## CORRECTION: Playmaster 300W Amplifier

**PLAYMASTER 300** (June 1980, 1/MA/55): In the quasi-complementary circuit shown on page 57, the 1 ohm/10W resistors associated with Q22, 23 and 24 do not ensure current sharing. To ensure current sharing in these transistors the circuit should be modified as shown in these diagrams. On the PCB, replace two of the 1 ohm resistors with 0.47 ohm/5W units and replace the two

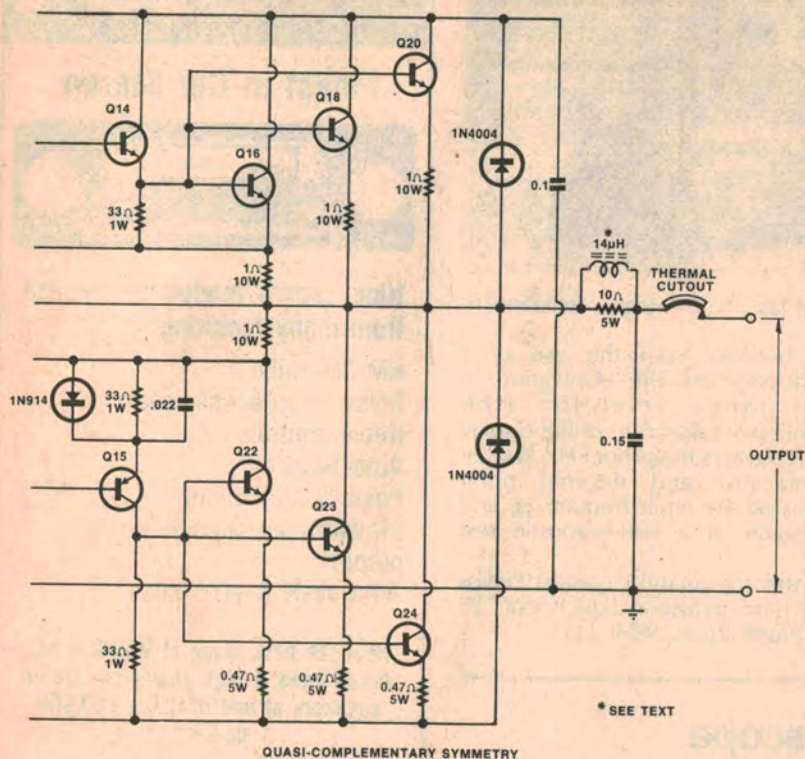
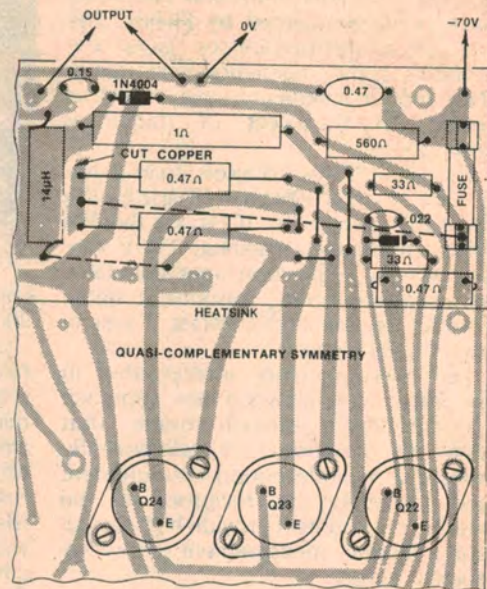
parallel links with a third 0.47 ohm/5W resistor. Delete one 0.1µF capacitor, cut the copper pattern as indicated and re-arrange links as shown. The two links shown dotted are on the underside of the board and should be made with insulated wire.

Note also that the PCB diagram on page 59 of the June 1980 issue should show the supply rails as  $\pm 70V$ , not  $\pm 75V$ .
